RE: SSD 7603; Nos. 24-28 John Street and Nos. 4, 6, 8, 10, 12, 14, 16, 18, 20, 22, 24, 26 and 28 Board Street, Nos. 3, 5, 7, 11, 13, 15 and 17 Ann Street, Lidcombe 2141 NSW

I object to part of the abovementioned proposal, namely the above-ground multistorey carpark that will be constructed on Board and Ann Street. I have not included any objection to the proposed hotel in this submission. Internet hyperlinks have been included for your convenience.

Figure 1

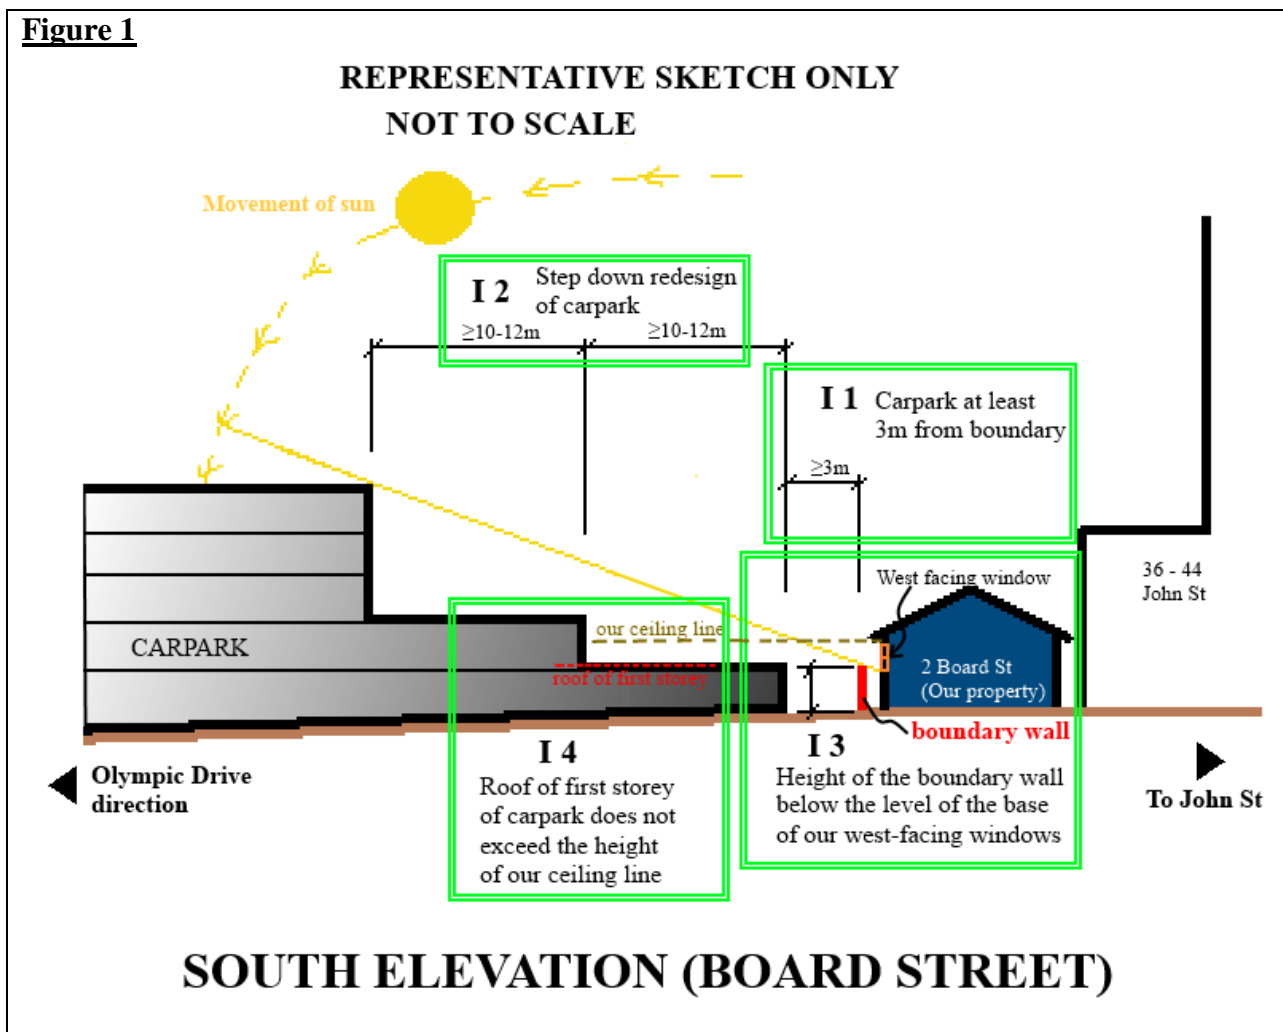
For the improvements mentioned below, please see Figure 1 for a representative view. I feel that all these changes are necessary to reduce overshadowing and to increase my solar access.

- I 1** Instead of building so close to the boundary, setback the proposed multilevel carpark **at least 3 metres** from our common boundary.
- I 2** Instead of the current design with no stepping down, change the design of the carpark such that there is a **step-down**, with the higher storeys being closer to Olympic Drive than those closer to my property. In Figure 1, I have shown a situation where I would increase my solar access. The eastern wall of the first storey could be spaced at least 10 – 12 metres from the eastern wall of the second storey. The eastern wall of the second storey could be spaced at least 10 – 12 metres from the eastern wall of the remainder of the storeys.

- I 3** Instead of the proposed boundary wall being built much higher than my single storey dwelling, build the boundary wall at or below the level of the *base* of the west-facing windows on my property.

- I 4** Ensure that the roof of the first storey of the carpark is no higher than the level of our ceiling of the west-facing rooms on my property.
